Anschlußflansch
für Lagerhalter

Neues
Pendel-
rollen-
lager

Alter
Bock für
Gleitlager

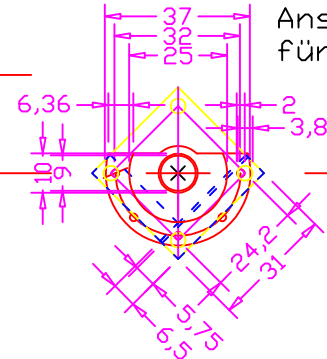
Dieses Maß überprüfen

Falsches Maß

M16?
